- Subject** ▶ Change of Noise Suppressor
- For Models** ▶ HP1300S, NHP1300S, 900, N900, 910, N910
- Country** ▶ All countries
- Description** ▶ Noise suppressor has been changed as shown below.
The wiring remains unchanged.

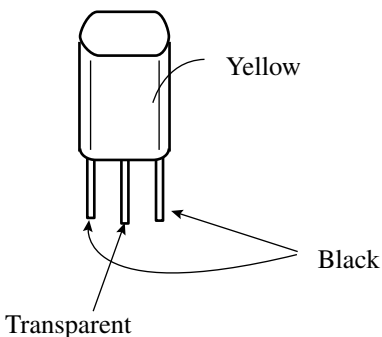
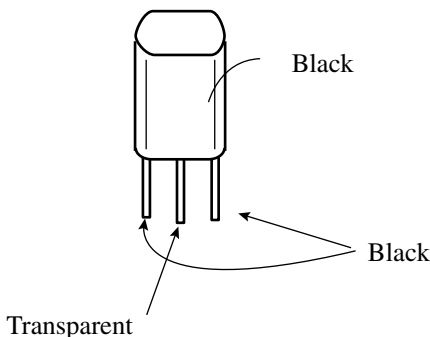
▶ Current	▶ New
 <p>Capacity: 150nF+2x2.5nF</p>	 <p>Capacity: 0.23uF+2x5000pF</p>

Item No.	Current part		Q'ty	I/C	New part		Q'ty	Note
See below.	Noise Suppressor 645111-0		1	Yes	Noise Suppressor 645173-8		1
